UNITED STATES PATENT AND TRADEMARK OFFICE

APPLICATION NO.	FILING DATE	FIRST NAMED INVENTOR	ATTORNEY DOCKET NO.	CONFIRMATION NO.
10/717,979	11/20/2003	Bernard Strong		8154

Office Action Summary

DETAILED ACTION

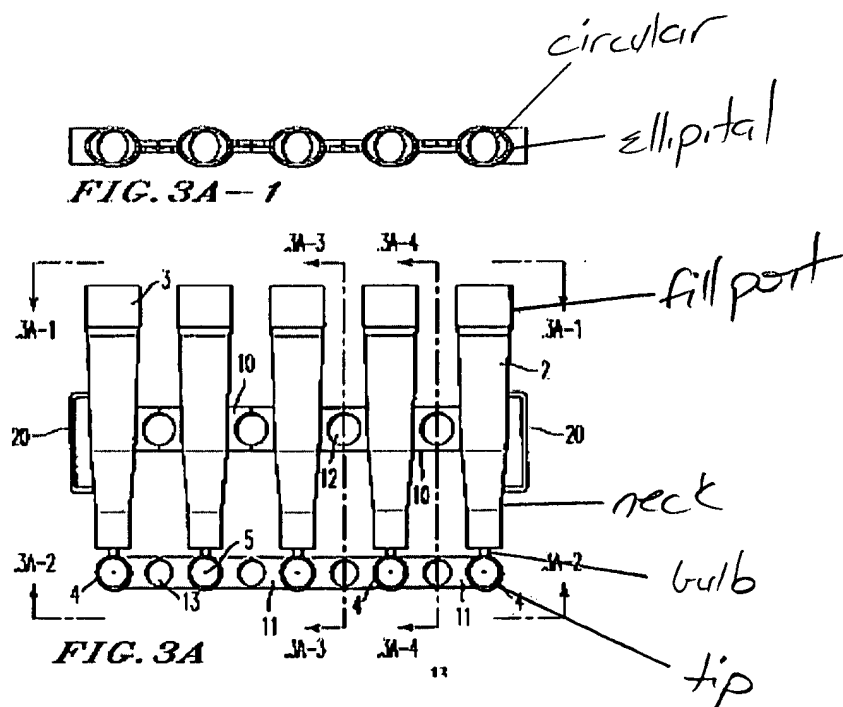
Claims 1-5, 8-15, 18 and 19 are rejected under 35 U.S.C. 102(b) as being anticipated by U.S. 6,116,449 to Chiesi et al.

The patent to **Chiesi et al.** discloses a container having a dispensing end and a filling end, wherein fig. 3A-1 best illustrates the filling end having a hollow fill port comprising a circular end proximal to the body and an elliptical end distal to the body, as recited in claims 1 and 11. Additionally, this figure discloses the distal end defining an opening suitable for use in filling the body with a product and the distal end tapers down to the proximal end. The dispensing end comprises a hollow neck in communication with the cavity at the proximal end of the hollow neck with respect to the body and a tip at a distal end of the hollow neck with respect to the body, with the tip comprising a bulb defining a cavity in communication with the hollow neck. The circular end flares out in a generally lateral direction to create the elliptical end, as recited in claim 9, and therefore the elliptical end tapers down to the circular end, as recited in claim 10.

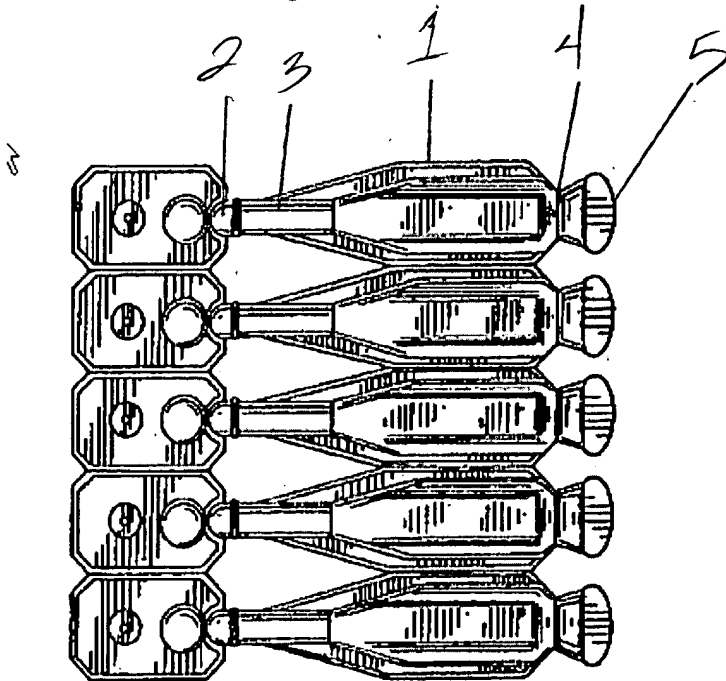
a dose container (10) including a body portion (11) having a tapered section (13) terminating at its upper end in a cylindrical neck portion (14). The lower end of the body portion is initially open to facilitate filling of a product and after filling is adapted to be sealed by application of heat and pressure to provide a welded seam.

Fig. 1 discloses the end portion (16) flaring out from the body (12) thereby providing an elliptical shaped end. It would have been obvious to one having ordinary skill in the art at the time the invention was made to modify the end of **Umekawa** so as to facilitate the filling of the container with a liquid material, as suggested by **Federighi**, in the event that the end of **Umekama** doesn't already function as a hollow fill port in order to insert liquid into the container.
